STAFF REPORT

PROJECT: Request for a Conditional Use Permit to Allow an Architecturally Integrated Subdivision (AIS) to create sixty-four (64) Multi-Family Townhomes (Use 1.321) at 501 Berryhill Drive

APPLICANT: Berryhill Group, LLC
PO Box 16009
Chapel Hill, NC 27516

PURPOSE: Berryhill Group, LLC has submitted an application for a Conditional Use Permit to allow an Architecturally Integrated Subdivision of sixty-four (64) multi-family townhome lots to be located 501 Berryhill Drive. The name for the project is Morgan Ridge.

Carr Ridge Area Roads

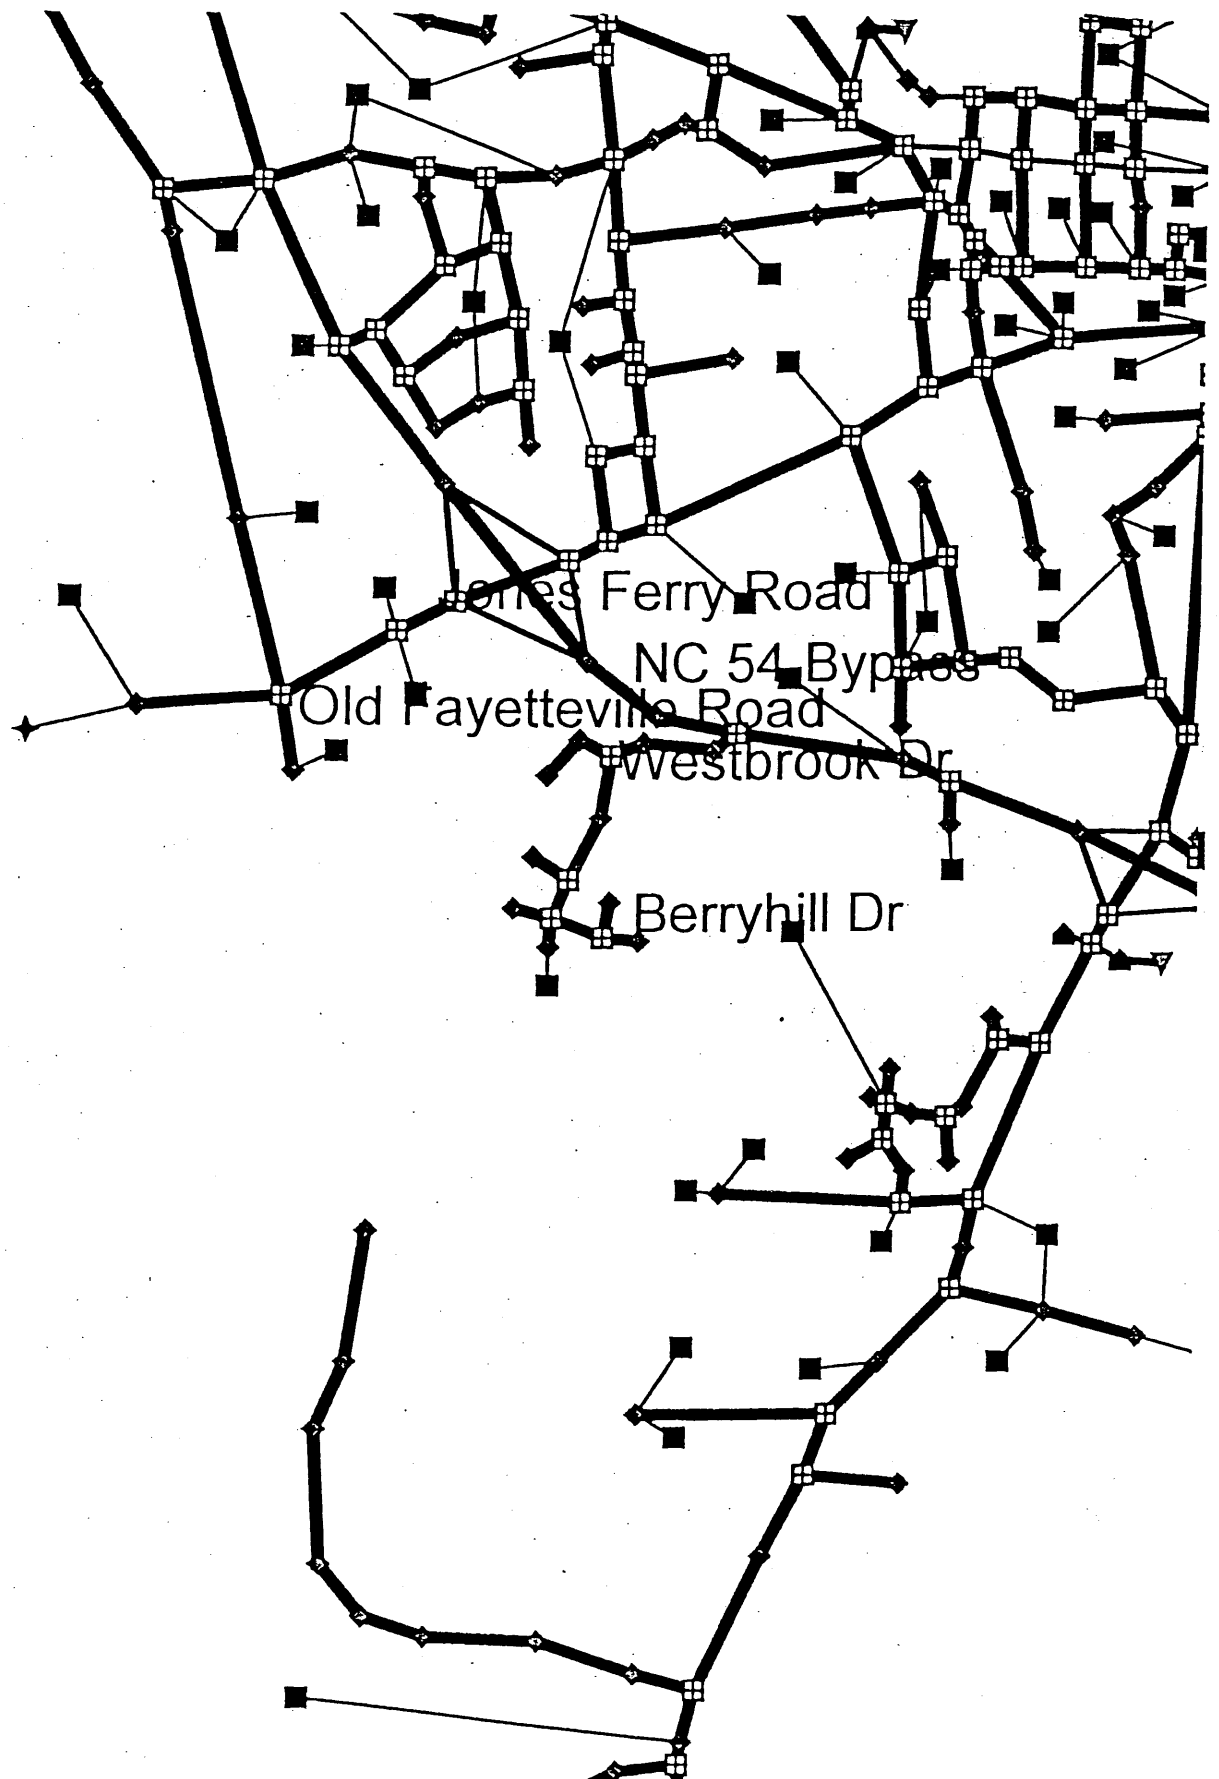
We have reviewed the plans for the proposed Carr Ridge Connector submitted by Philip Post and Associates dated 10/9/97. This plan was discussed at the Development Review Meeting on 10/29/97. Following are our comments regarding the plans:

- 1) We see no reason that the 35 mph design speed cannot be accomplished. Adjustment to the grades and/or length of curve can be used to create a 35 mph design.
- 2) The culvert system shown on the plans does not appear to be practical. Only three of the culverts shown appear to be within the channel area. It is likely the other 6 culverts will silt up over time and provide little or no significant conveyance during large storms. Even with significant channel improvement in the head and tail ditch, it is likely that the stream will re-establish its natural shape over time.
